UNITED STATES PATENT AND TRADEMARK OFFICE

APPLICATION NO.	FILING DATE	FIRST NAMED INVENTOR	ATTORNEY DOCKET NO.	CONFIRMATION NO.
10/809,137	03/25/2004	Rong-Faa Wu	LELI 3512	7726

Office Action Summary

DETAILED ACTION

Attachment #1

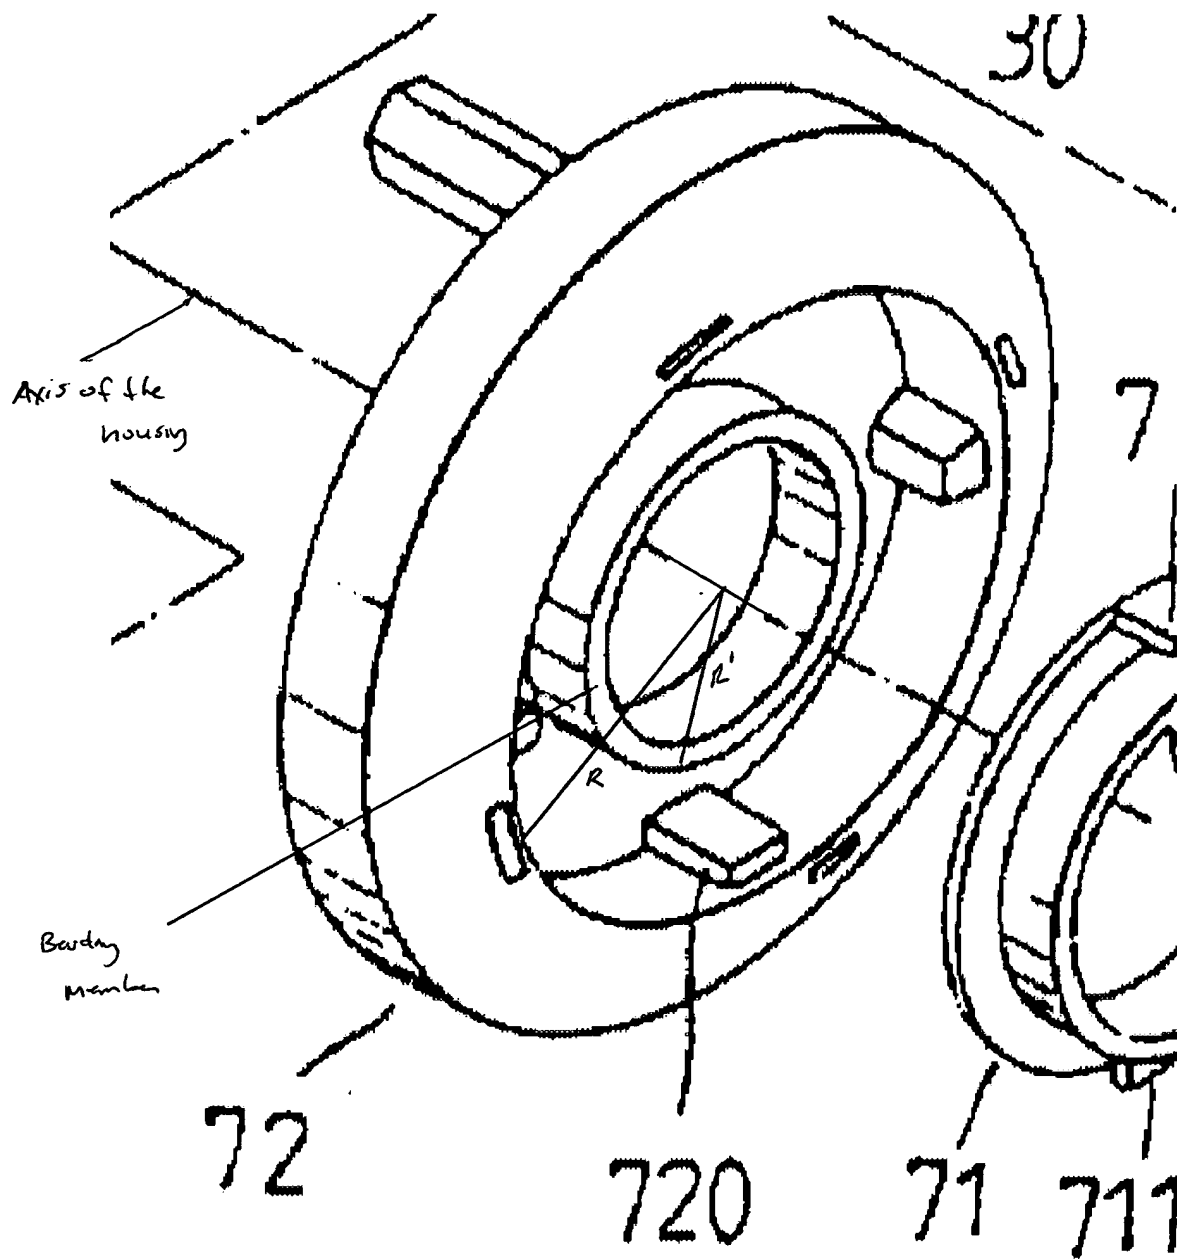
Regarding claim 1, Hu discloses a reinforced apparatus comprising a housing (72) provided with a recess formed thereon and at least one protruding portion (720) disposed at a predetermined position of the housing; and a rotary member including a first side plate (71), a second side plate (74) and a coiled spring (73) disposed between the first side plate and the second side plate. The coiled spring has a leg for abutting against the at least one protruding portion of the housing.

Hu further discloses a bending member, that when the rotary member and the coil spring are disposed inside the recess of the housing, the bending member is adapted to engage the second side plate in order to keep the rotary member positioned within the recess and operated by an external force.

The bending member will be positioned at a distance with respect to an axis of the housing smaller than a distance from the axis of the housing to the outer edge of the second side plate (see attachment #1).
